STAFF REPORT  
(Preliminary Plat)

CASE NUMBER: SUB 2000-13 -- ALFIERI ACRES ADDITION

**SUB 2000-13 -- Preliminary Plat of ALFIERI ACRES ADDITION**  
**March 23, 2000 - Page 3**

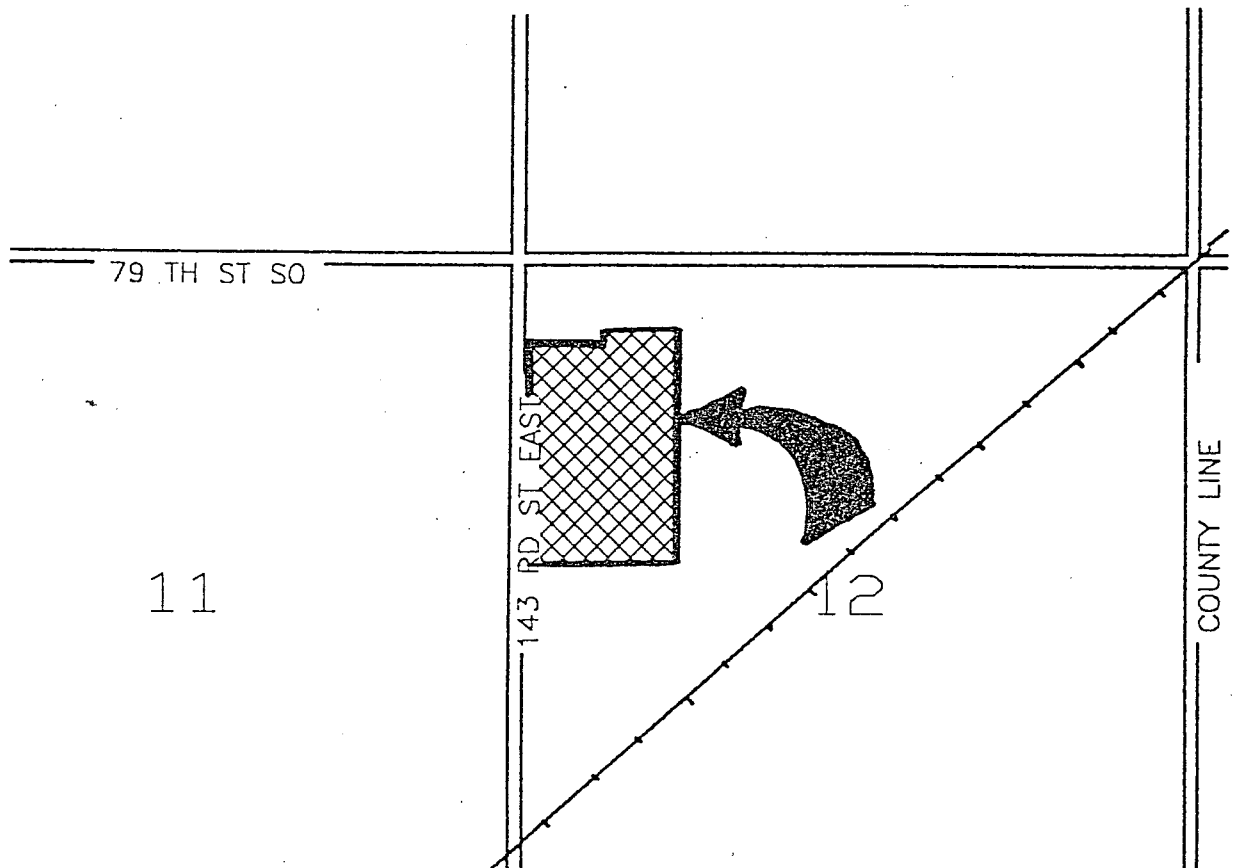
- C. **County Engineering** needs to comment on the status of the applicant's drainage concept. *A dedicated Floodway Reserve is required along the south line of Lot 8. The Applicant shall coordinate the modification or removal of terraces with NRCA.*

- F. The street name Springdale shall be replaced with 143<sup>rd</sup> St. East.
- G. **County Engineering** needs to comment on the need for additional street right-of-way. *50-ft of half-street right-of-way shall be dedicated for 143<sup>rd</sup> St. East.*

- H. **County Engineering** recommends the elimination of 83<sup>rd</sup> St. South to be replaced with a loop street connecting the north and south terminus of Gordin Circle/Court with 143<sup>rd</sup> St. East.

- I. **County Fire Department/County Engineering** needs to comment on the plat's street names. *It is recommended that Gordin Court/Circle be replaced with another name as Gordon St. exists in Wichita.*

- M. A legal description of the plat is needed.
- N. **County Engineering** requests that the existing road easement to the east shall be replaced with a dedicated street right-of-way.
